TECHNICAL SERVICE BULLETIN

Adaptive/Active Steering - Check Adaptive/Active Steering Message Illuminated With DTC C1B00

16-2066
03 November
2016

Ford 2016 Edge
Lincoln 2016 MKX

Figure 1

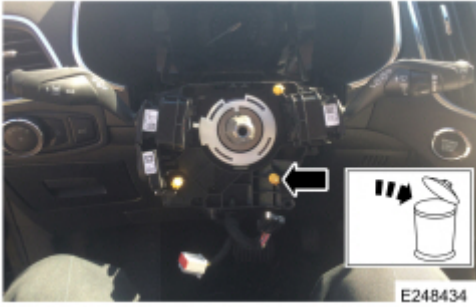
3. Before installing a new steering wheel, remove and discard the yellow boot on the lower right alignment pin on the multifunction switch. (Figure 1)
4. Install a new steering wheel. Refer to WSM, Section 211-04.
